#### Letter 45

#### ADAMS BROADWELL JOSEPH & CARDOZO

> Re: <u>Draft Environmental Impact Report for Mace Ranch Innovation Center</u> Project (SCH # 2014112012)

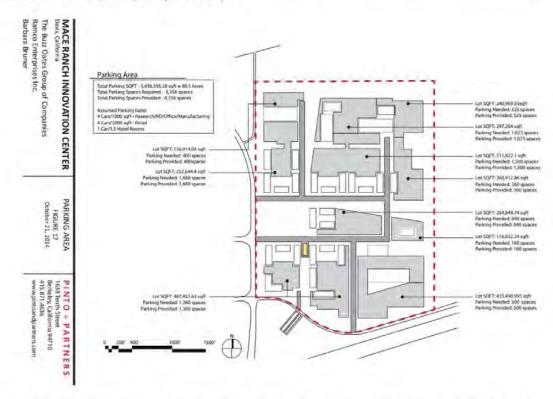
The Project's CalEEMod output files show that the "Land Use Types" and "Sizes" utilized in the emissions model are inconsistent with information disclosed in the DEIR. The DEIR states that the proposed Project encompasses a total of 228.58 acres, which consists of the 212-acre MRIC site and the 16.49-acre Mace Triangle site (DIER, p. 3-1). However, review of the CalEEMod output files for both the air quality and greenhouse gas assessment indicate that emissions were modeled assuming a total of only 63.88 acres of development. This is less than one-third of the entire Project area, resulting in a huge underestimation of Project emissions.

However, the "Green Space", "Landscaped Parking", and "Transit Plaza" proposed land uses (outlined in red) for the MRIC were not included in the air modeling conducted in the DEIR, as shown in the excerpt below.

Land Uses	Size	Metric	Lot Acreage	Floor Surface Area	Population
Research & Development	1,510,00	1000sqft	34.66	1,510,000.00	0
Research & Development	45.90	1000sqft	1.05	45,901.00	0
Manufacturing	884.00	1000sqft	20.29	884,000.00	0
Hotel	150.00	Room	5.00	217,800.00	0
Regional Shopping Center	100.00	1000sqft	2.30	100,000.00	0
Regional Shopping Center	25.16	1000sqft	0.58	25,155,00	0
